**RESPONSE TO REQUEST FOR ADDITIONAL INFORMATION
IN REGARDS TO REQUEST FOR LICENSE AMENDMENT
INCREASED LICENSED POWER LEVEL
SALEM GENERATING STATION, UNIT NOS. 1 AND 2
FACILITY OPERATING LICENSE DPR-70 AND DPR-75
DOCKET NOS. 50-272 AND 50-311**

**ATTACHMENT 1
SALEM GENERATING STATION
UNIT NOS. 1 AND 2
FACILITY OPERATING LICENSE DPR-70 AND DPR-75
DOCKET NOS. 50-272 AND 50-311
RESPONSE TO REQUEST FOR ADDITIONAL INFORMATION
INCREASED LICENSED POWER LEVEL**

**SALEM GENERATING STATION
UNIT NOS. 1 AND 2
FACILITY OPERATING LICENSE DPR-70 AND DPR-75
DOCKET NOS. 50-272 AND 50-311
CHANGE TO FACILITY OPERATING LICENSES**

Figure 3.4-3

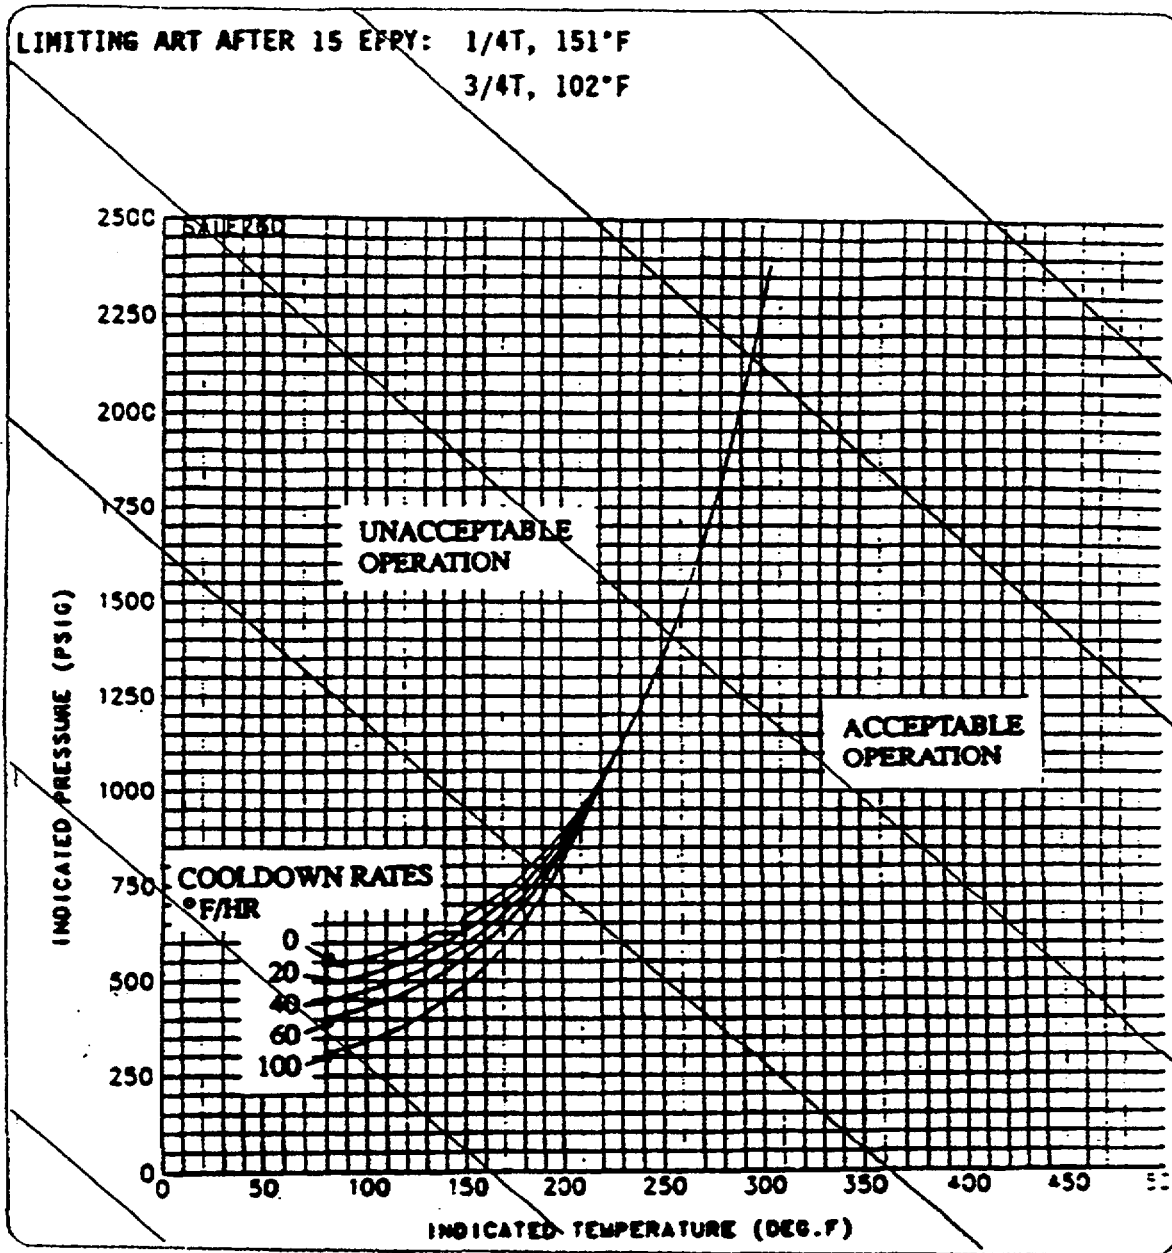
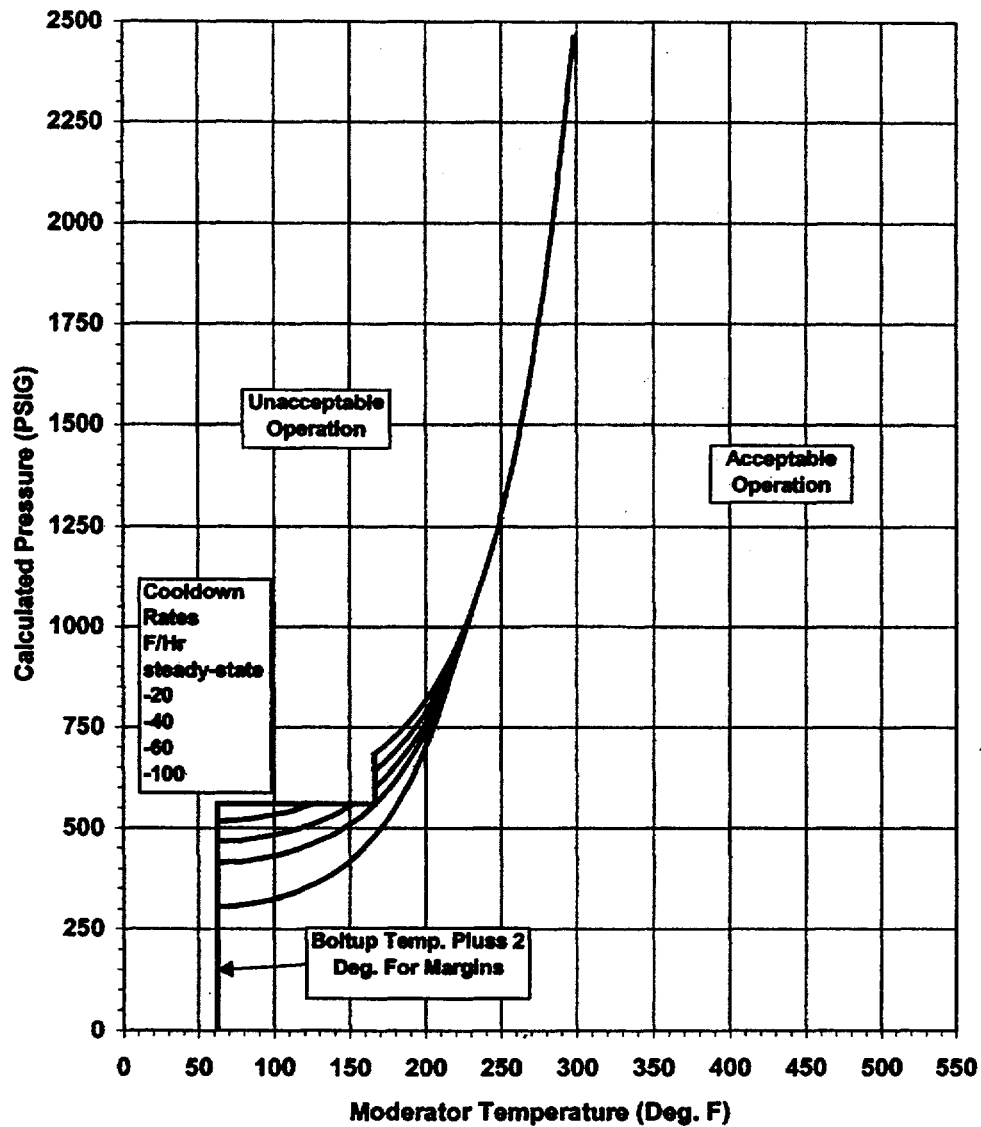
32

RT_{NDT} after 32 EFPY: 1/4T 199°F
 3/4T 140°F

1. Technical Specification Figures 3.4-2 and 3.4-3, Reactor Coolant System Heatup and Cooldown Curves, and their associated Bases are revised to support the increase in core power based on uprated fluence projections. The revised curves are applicable for the service period up to 32 effective full power years (EFPY). The maximum heatup rate for Figure 3.4-2, Reactor Coolant System Heatup Limitations, is being changed from 60°F/hr to 100°F/hr. The revised curves are being adjusted to account for pressure and temperature instrument uncertainties and the curves are being extended to show minimum boltup temperature. The values in Bases Table B 3/4.4-1, Reactor Vessel Toughness Data, for Unit 1 and 2 are being updated to reflect information related to reactor pressure vessel integrity previously provided to the NRC in response to Generic Letter 92-01 and its supplement.
